December 12, 2023

To: City of Albuquerque Planning Department
Plaza del Sol Building
600 Second NW
Albuquerque, NM 87102

Re: **Storage Facility**
Project #: PR-2020-004645
Application #: SI-2023-01803

Please find the following responses addressing comments received in a letter dated November, 29 2023. In an effort to address your comments concisely and simplify your review of these development plans, we have summarized your comments and our responses below. Your comment is listed first, followed by the response in Bold.

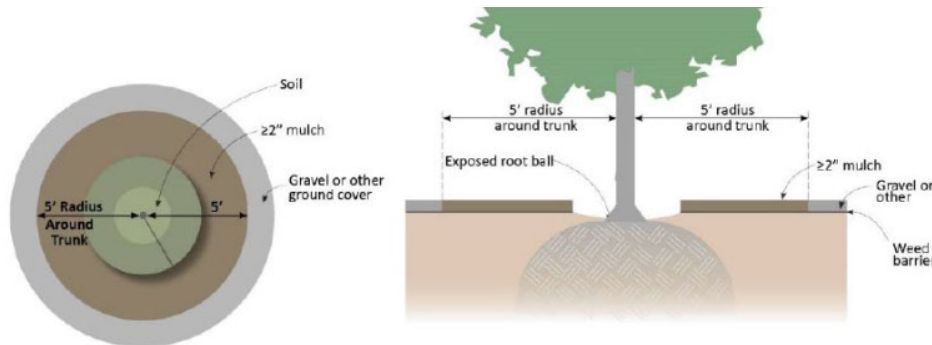
12. Per 5-5(E) BICYCLE PARKING, 3 spaces or 10% of required off-street parking spaces is required. Please show where bicycle parking is located on Site Plan.

Response: See site plan keyed note #7.
